Form 3160-5 (June 2019)

1. Type of Well		MULTIPLE		
Oil Well Gas Well Other		8. Well Name and No. MULTIPLE		
2. Name of Operator EOG RESOURCES INCORPORATED		9. API Well No. MULTIPLE		
3a. Address 1111 BAGBY SKY LOBBY 2, HOUSTON, TX 770 (713) 651-700	10. Field and Pool or MULTIPLE	Exploratory Area

4. Location of Well (Footage, Sec., T.,R.,M., or Survey Description) MULTIPLE	11. Country or Parish MULTIPLE	ı, State		
12. CHECK THE APPROPRIATE BOX(ES) TO INI	DICATE NATURE OF NOT	ICE, REPORT OR OT	HER DATA	
TYPE OF SUBMISSION	TYPE OF AC	TION		
Notice of Intent Acidize Deep Alter Casing Hydr		luction (Start/Resume)	Water Shut-Off Well Integrity	
Subsequent Report ==	=	omplete porarily Abandon	Other	
Final Abandonment Notice Convert to Injection Plug	_	er Disposal		
is ready for final inspection.) EOG respectfully requests an amendment to our approved APD for thi the following changes: Update casing and cement program to current design. EOG requests execution of Variance 3a (attached) to offline cement the

YUKON 20 FED COM 101H, US Well Number: 3002550397, Case Number: NMNM17241, Lease Number: NMNM17241, Operator:EOG RESOURCES INCORPORATED

Figure 1: Cameron TA Plug and Offline Adapter Schematic

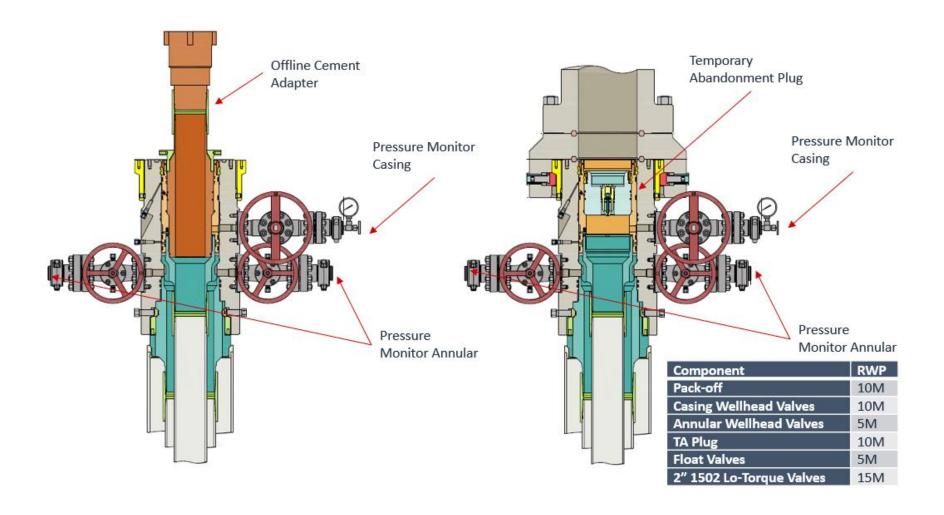
- c. Return line schematics can be seen in Figure 3.
- 10. Remove TA Plug from the casing.
- 11. Install offline cement tool.
 - a. Current offline cement tool schematics can be seen in Figure 1 (Cameron) and Figure 2 (Cactus).
